Access Compliance Report

Public Rights-of-Way

(Curb Ramps)

Intersection ID: 12101	Main Street: N_TRYON_ST	Cross Street: E_6TH_ST	Location:	E
ADA ID: F007F97088A4	Ramp Type: PerpDiag	Initial Pass/Fail: Pass	Overall Compliance: No	Severity Score: 2.5
Codes/Mitigation Info/Possible Solution		Field Measurements/Component Compliance

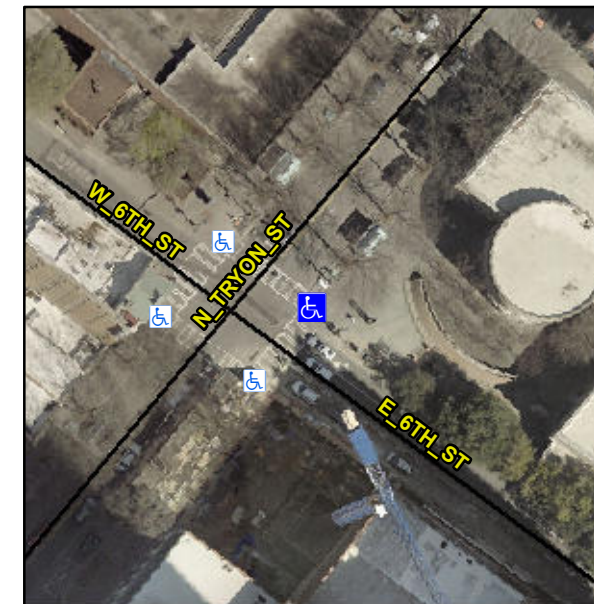
Remove & Replace Detectable Warning System.

R305.1.4
